TO: Board Members – Vancouver Park Board
FROM: General Manager – Parks and Recreation
SUBJECT: Aquarium Revitalization & Expansion Proposal:
Technical Review and Public Consultation Process

Technical Review: Impacts of the Proposed Aquarium Revitalization and Expansion on Stanley Park (September 2006)

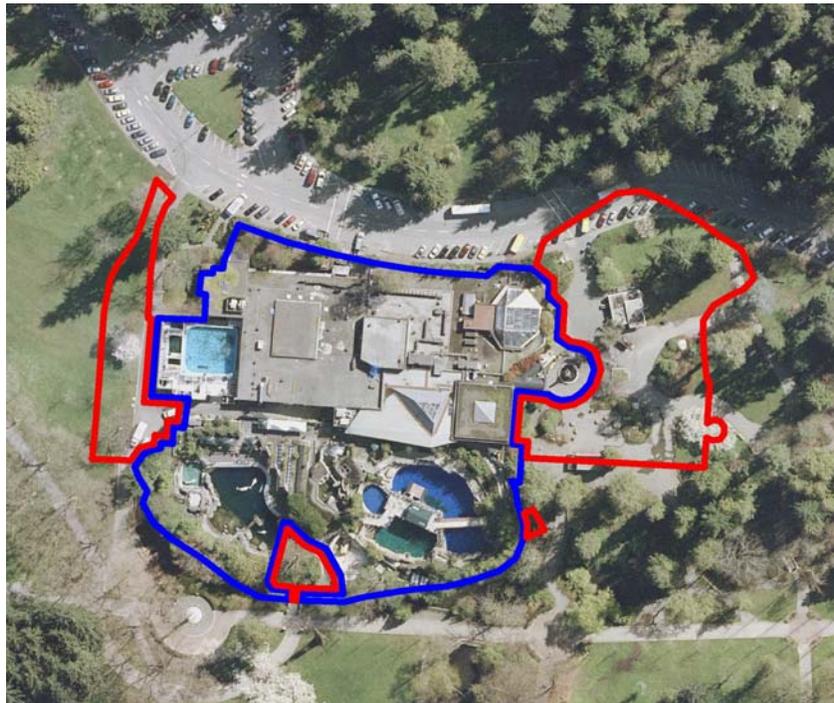
When the Aquarium opened in 1956, it covered about 0.13 hectares (0.33 acres) of land in Stanley Park. The Aquarium was expanded 8 times in the last 50 years. Today, the Aquarium occupies 1.2 hectares (2.9 acres) in Stanley Park (outlined in blue on the map).

The proposal would increase the Aquarium's footprint to 1.8 hectares (4.4 acres), an addition of 0.6 hectares (1.5 acres) or a 50% increase (outlined in red on the map).

The Park Board has been and is very cautious about removing portions of Stanley Park from the public domain (either by fully restricting public access or requiring a fee for entry).

The evaluation depends on the value assigned to the land in question: whether it is believed that Stanley Park is better served by having the land kept as publicly-accessible open space, or by having the land incorporated as part of a successful educational and tourist institution.
